COMMONWEALTH of VIRGINIA

September 17, 2010

MEMORANDUM

To: All Holders of the Virginia Department of Transportation's 2008 Road and Bridge Standards

VDOT	
ROAD AND BRIDGE STANDARDS	
SHEET 1 OF 2	REVISION DATE
104.09	08/10

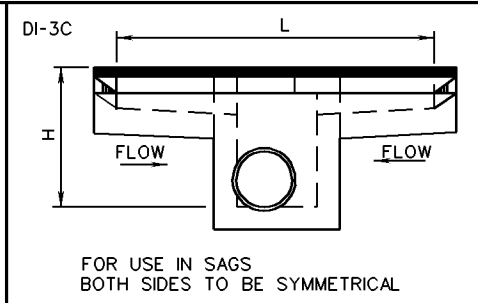
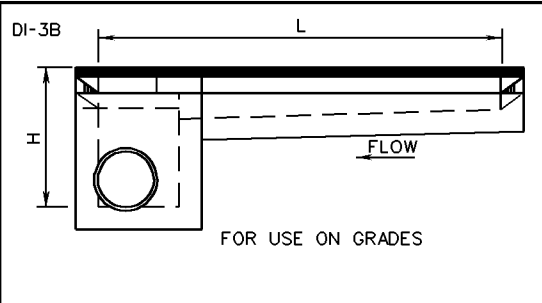
PAGE	REVISION
104.09	Clarified Type B nose detail note
114.01	Corrected note callout
114.02	Corrected note callout
501.11	Clarified note C and section callouts
501.16	Clarified note C
501.18	Clarified direction of traffic
501.19	Corrected description for one way traffic
502.21	Changed note 5 from "shall be" to "may be"
502.22	Changed note 5 from "shall be" to "may be"
603.02	Clarified exit taper ratios

TYPE A NOSE DETAIL SHALL BE USED WITH CG-3 & CG-7 STANDARDS.
 TYPE B NOSE DETAIL SHALL BE USED WITH CG-2 & CG-6 STANDARDS.
 GALVANIZED PLATE FOR TYPE A TO BE BENT ON AN ANGLE OF 68° 30' CONNECTORS AND IS TO BE ANCHORED WITH 1/2" X 4" STUD SHEAR WELDED TO BENT PLATE AT 2' C-C.

203.08A

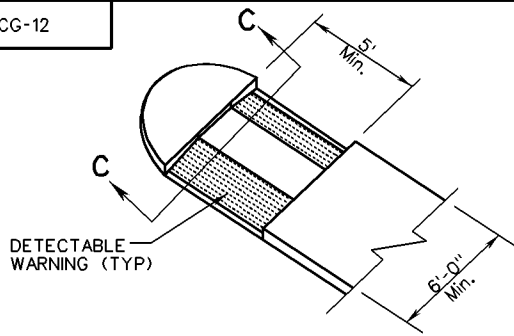
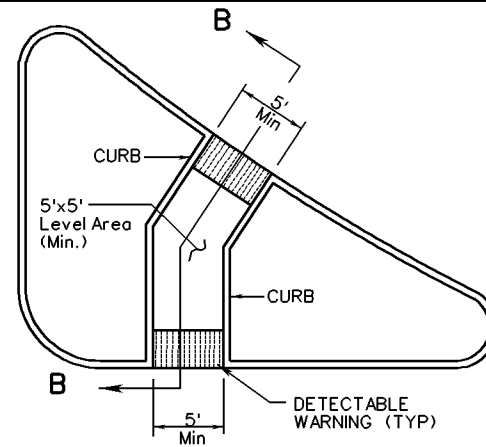
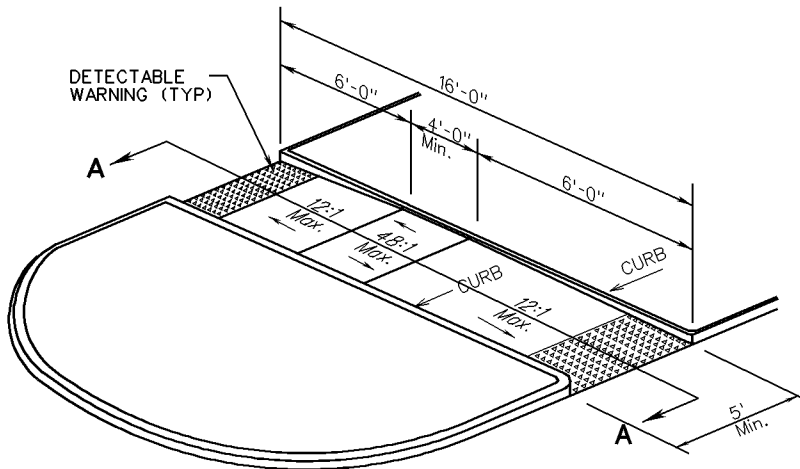
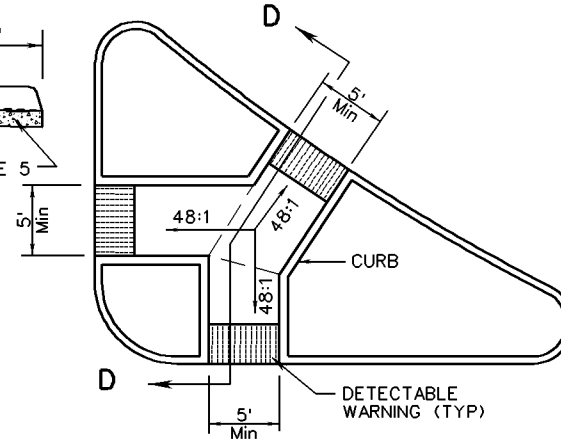
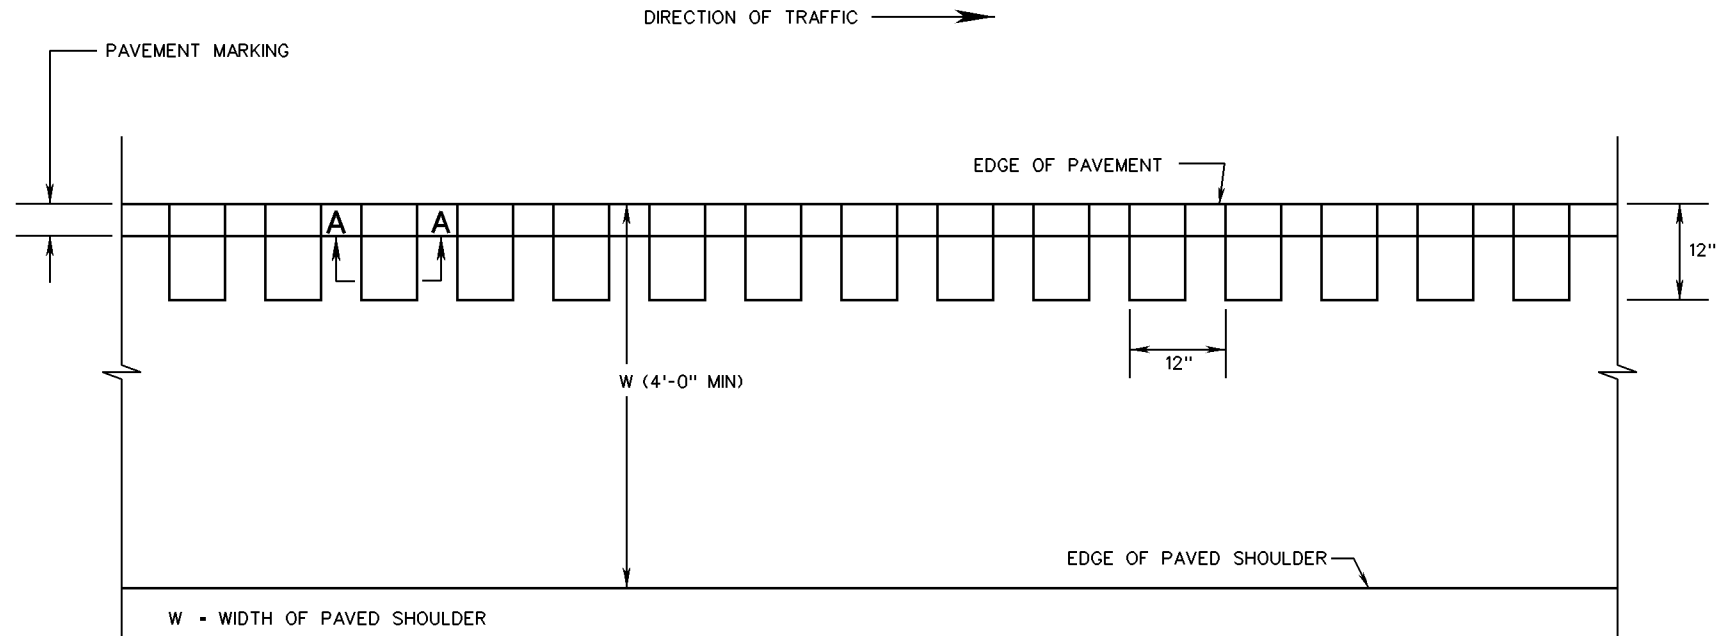
PAGE	INTERIM	STANDARD	REVISION
203.08A	IIS02_05	CG-12	CLARIFIED SECTIONS TO SHOW CONCRETE SIDEWALK AND ADDED NOTE 5
304.03	IIS03_05	RS-4	REVISED FORMAT OF SHEET
304.04	IIS03_06	RS-5	REVISED FORMAT OF SHEET
305.01	IIS03_07	ACOT-1	NEW ASPHALT CONCRETE OVERLAY TRANSITION STANDARD REPLACES THE TPT-1 STANDARD
501.10	IIS05_07	GR-6	REVISED END ANCHORAGE BOLT SIZE TO MATCH CRASH TESTED TERMINAL
501.39	IIS05_08	GR-INS	REMOVED RADIAL GUARDRAIL, ADDED REQUIREMENT FOR GR-2A TO BE UTILIZED WITH CURB & GUTTER, ADDED DETAIL FOR MEASURING GUARDRAIL HEIGHT
601.05	IIS06_01	HR-1	REVISED STANDARD TO REFLECT PEDESTRIAN RAILINGS AND BICYCLE RAILINGS, ADDED GRIPPING RAIL DETAIL AND REQUIREMENT FOR SHOP DRAWINGS TO BE SUBMITTED
1005.17	IIS10_01	BCQ-30	REVISED FORMAT OF SHEET
